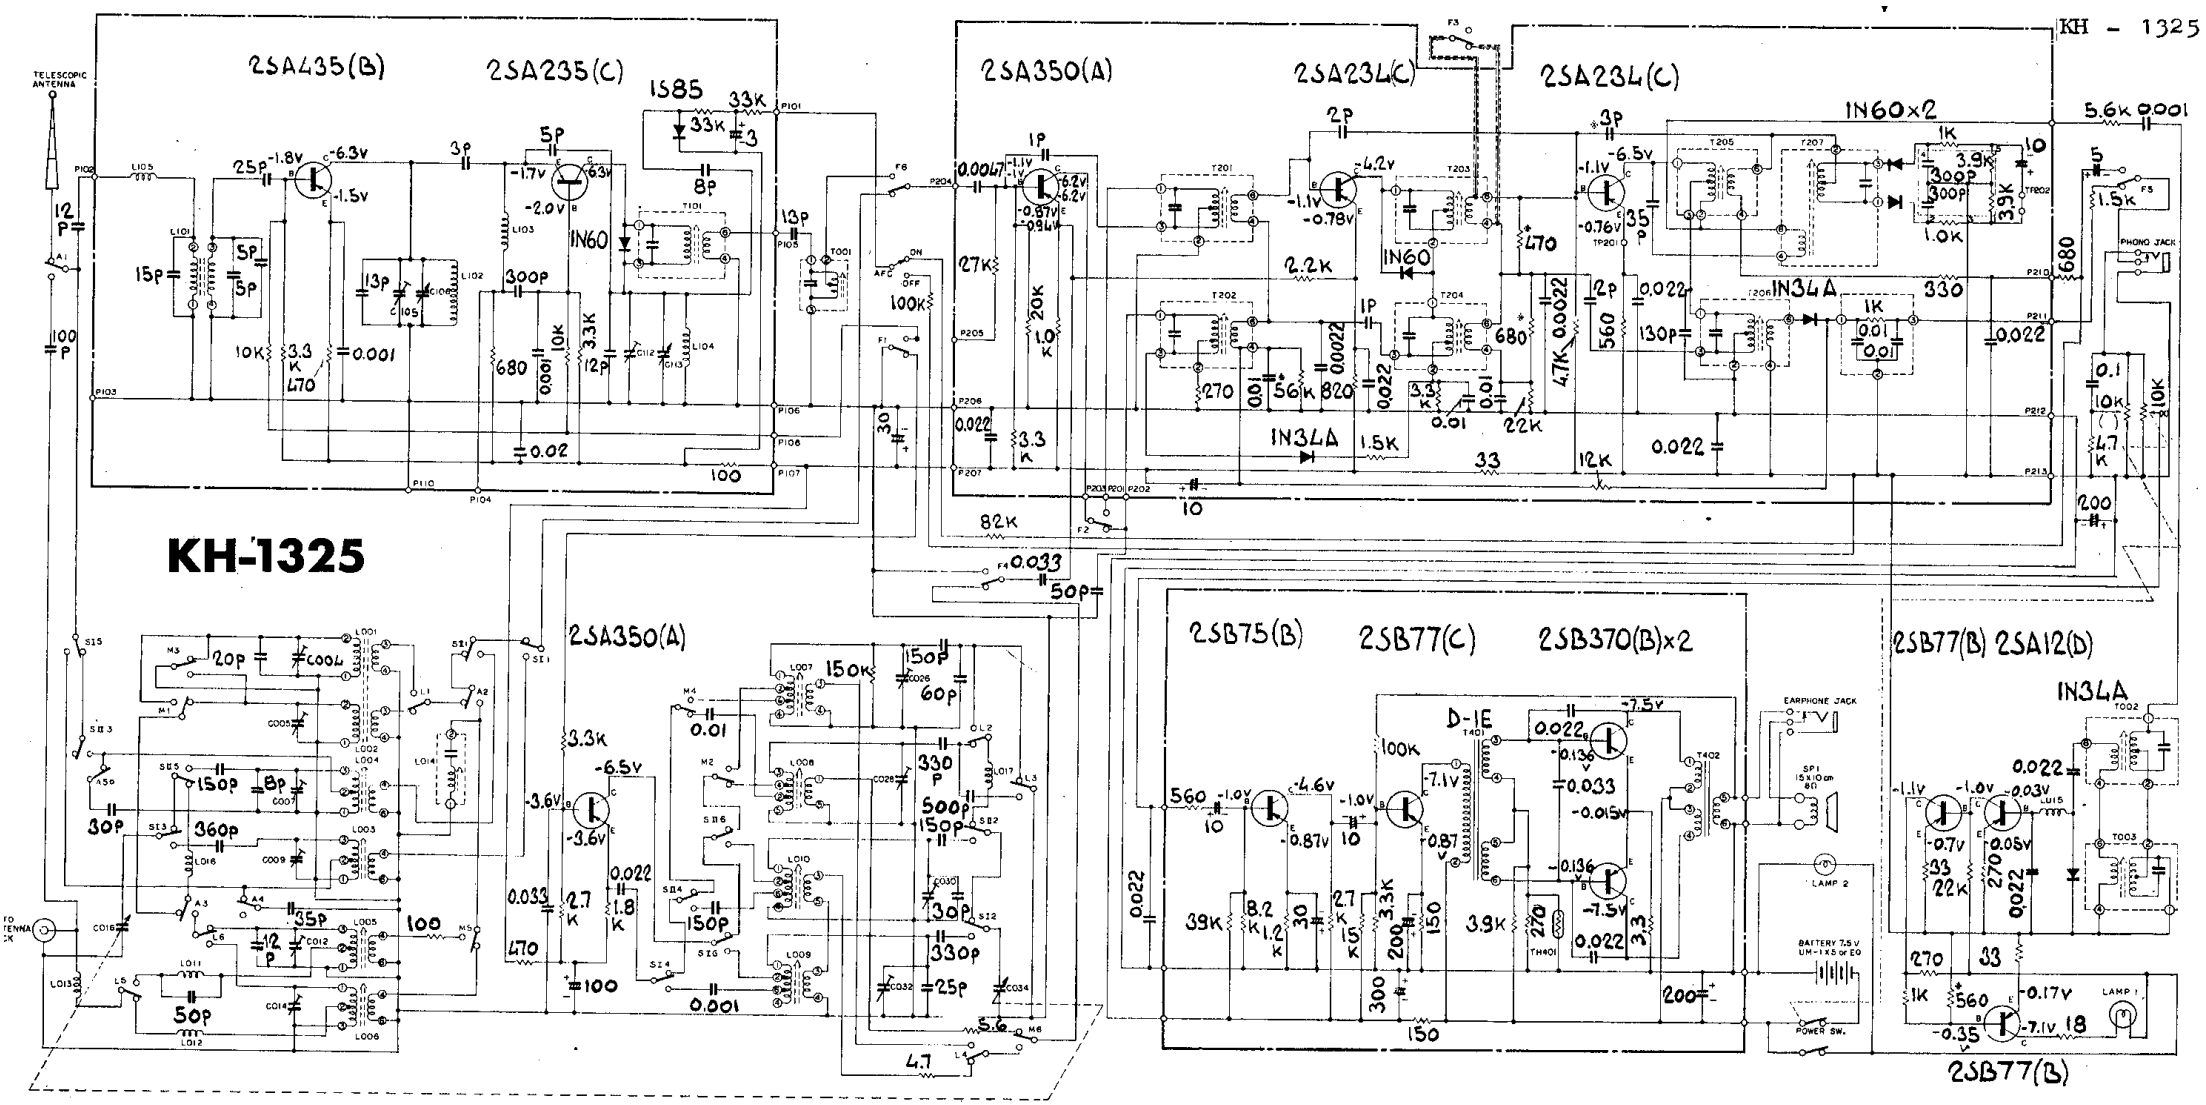
Note: 1) C_{218} and C_{219} are changed to 1000pF.
2) R_{210} is changed to 680Ω.
3) R_{211} is changed to 330Ω.
